UNITED STATES DEPARTMENT OF COMMERCE United States Patent and Trademark Office Address: COMMISSIONER FOR PATENTS P.O. Box 1450 Alexandria, Virginia 22313-1450 www.uspto.gov

APPLICATION NO.	FILING DATE	FIRST NAMED INVENTOR	ATTORNEY DOCKET NO.	CONFIRMATION NO.	
10/700,292	11/03/2003	Phillip M. Gibbs	5490-000224/US/CPB	6515	
27572 7590 10/31/2007 HARNESS, DICKEY & PIERCE, P.L.C. P.O. BOX 828			EXAM	EXAMINER	
			RAMANA, A	RAMANA, ANURADHA	
BLOOMFIELD HILLS, MI 48303			ART UNIT	PAPER NUMBER	
			3733		
			MAIL DATE	DELIVERY MODE	
			10/31/2007	PAPER

#### **DETAILED ACTION**

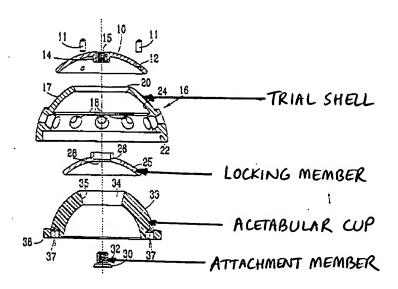
Doursounian et al. disclose a system including: a trial shell including an attachment device or hole therein; an acetabular cup 33; an attachment member 30; and a locking member 25 to operably couple the attachment member to the trial shell (Fig. 2, col. 2, lines 54-67 and cols. 3-4). See Fig. 2 below, marked up to show elements of Applicant's invention.

The method steps of claims 23 and 25-32 are inherently performed when the Doursonian et al. system is trialed to determine the final stable orientation.
